**CAMINO REAL REGIONAL MOBILITY AUTHORITY
BOARD RESOLUTION**

CONSTRUCTION CONTRACT CHANGE ORDER NUMBER #1

5. New or revised plan sheet(s) are attached and numbered: New Sheets Old Hueco Tanks Rd Single Box Culverts Cast in Place

Re: *Change Order #1 Cast in Place in lieu of Pre Cast Box Culvert.*
Old Hueco Tanks Improvement Project
TxDOT CSJ 0924-06-111

**OLD HUECO TANKS RD
 MESA DRAIN
 SINGLE BOX CULVERTS
 CAST-IN-PLACE
 0' TO 30' FILL
 SCC-10 (MOD)**

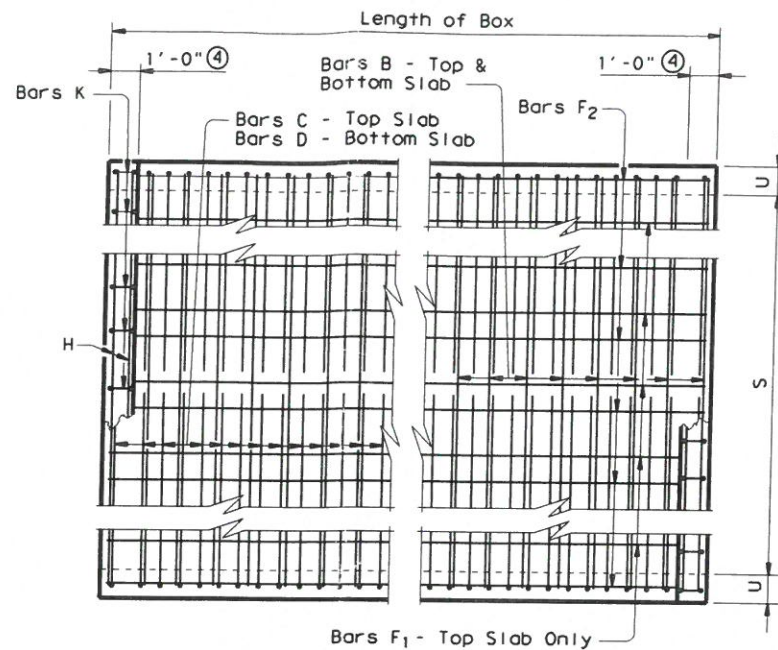
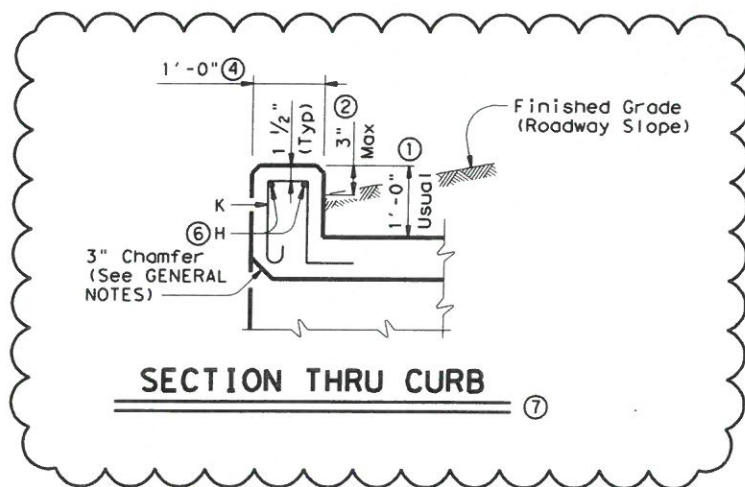
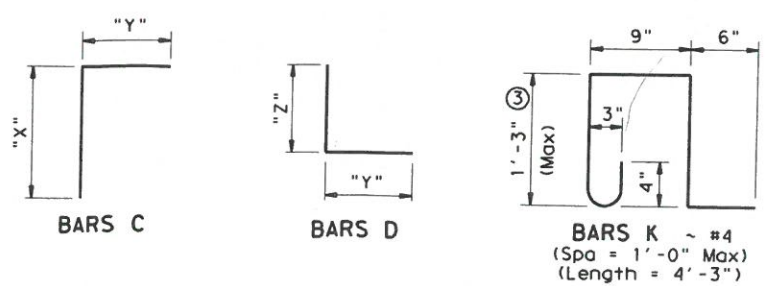
Original plans required box culverts at Mesa Drain and Mesa Spur to be Pre-cast. See attached original plans sheets 100 and 104. During Construction activities, the contractor proposed a revised design to the box culverts and requested a change in method of work to cast in place. The contractor submitted revised plans for a cast in place box culverts in lieu of pre cast at Mesa drain STA 9+00 OHT CL and Mesa Spur 43+80 OHT CL. See design drawings for cast in place SCC 10 and SCC 5&6.

This letter is to inform you that the Contractor International Eagle Inc, has proposed to change the pre cast box culverts to cast in place at Mesa drain STA 9+00 OHT CL and Mesa Spur 43+80 OHT CL. Original plans required box culverts at Mesa Drain and Mesa Spur to be pre-casted. See attached original plans sheets 100 and 104. The contractor submitted revised plans for a cast in place box culverts in lieu of pre cast. See design drawings for cast in place SCC 10 and SCC 5&6.
